<input checked="" type="checkbox"/> ECO <input type="checkbox"/> ECR		NO. 4026	EFF. DATE OF CHG 2/22/94	REQUESTED BY J. JONES	PREMIER	PAGE 1 OF 3
REASON FOR CHANGE DRAWING IMPROVEMENT		DOCUMENTS EFFECTED 206-AA-1002	SYSTEM INSTALL, MOUNTING PROVISIONS, BELLY		MATL DISPOSITION	
MARKED PRINTS ATTACHED YES <input type="checkbox"/> NO <input checked="" type="checkbox"/>			SERIAL NO EFF 206 SERIES		REWORK	STORE
DISPOSITION/COMMENTS REV. "IS" B			THIS IS AN UNINCORPORATED ECO (STC SH3763SW)

SECTION B-B

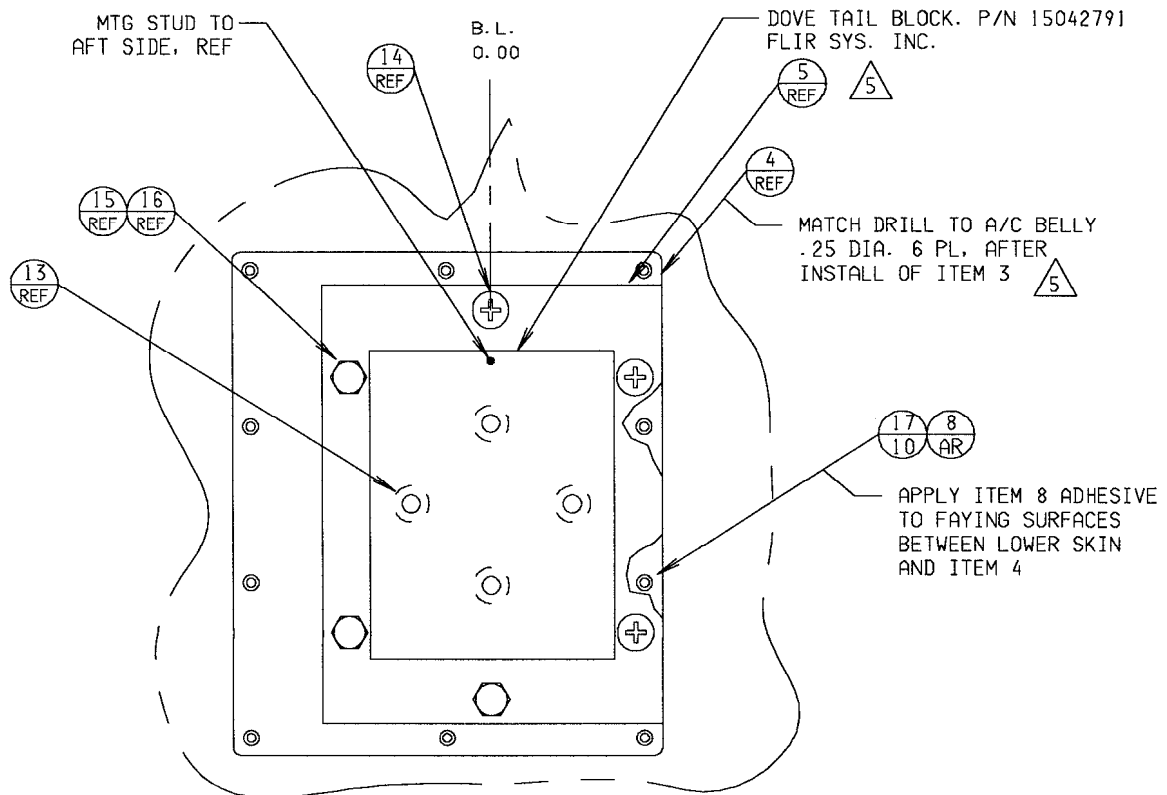
"CHANGED" SECTION B-B ZONE 2C

LKG UP AT BELLY
FINISH; PAINT ALL PARTS
EXCEPT DOVETAIL BLOCK TO
MATCH ACFT BELLY

"WAS"

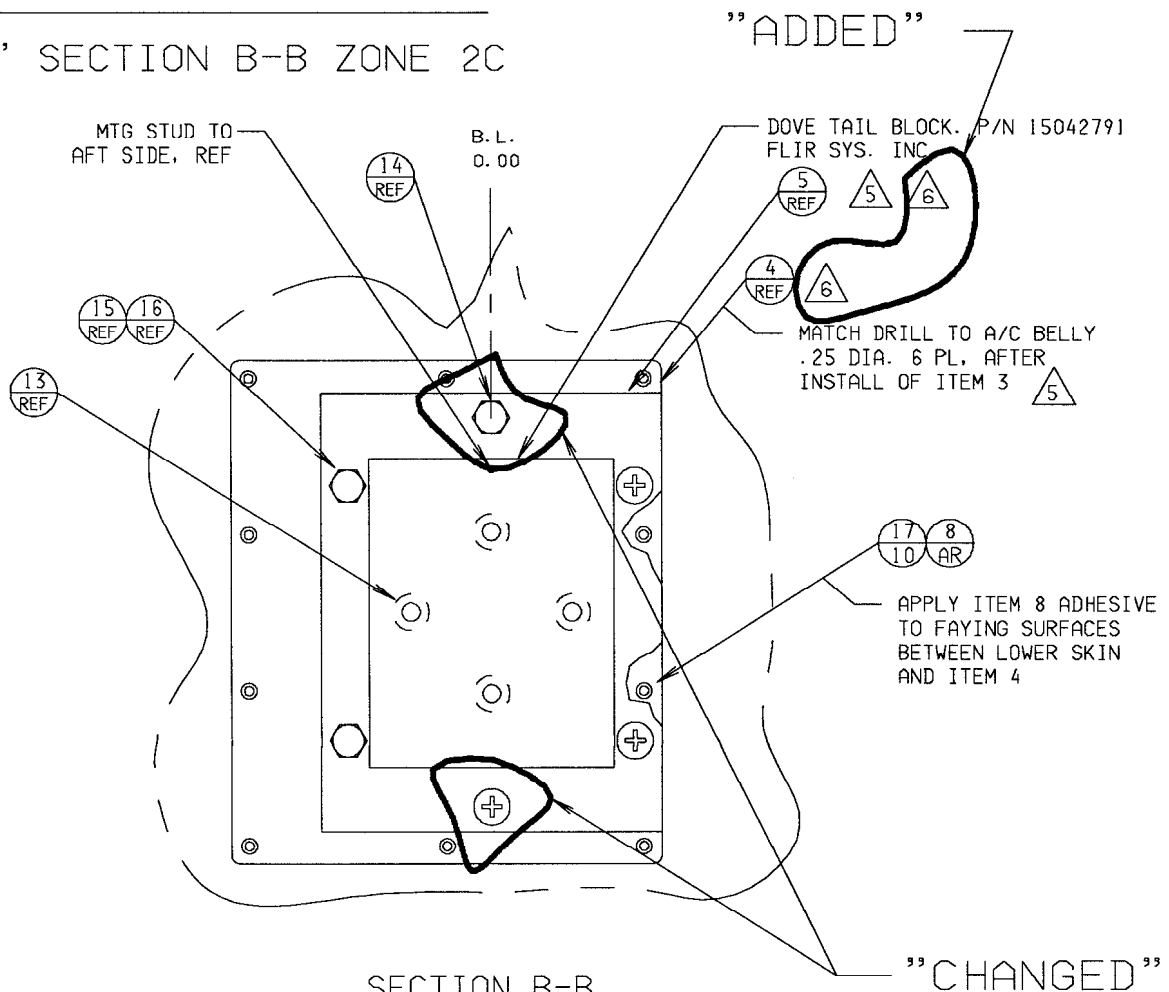
"CHANGED" MADE THE SAME CHANGE TO SECTION D-D ZONE 3B
THAT WAS MADE TO SECTION B-B ZONE 2C SHEET 1A

"CHANGED" SECTION B-B ZONE 2C

"IS"
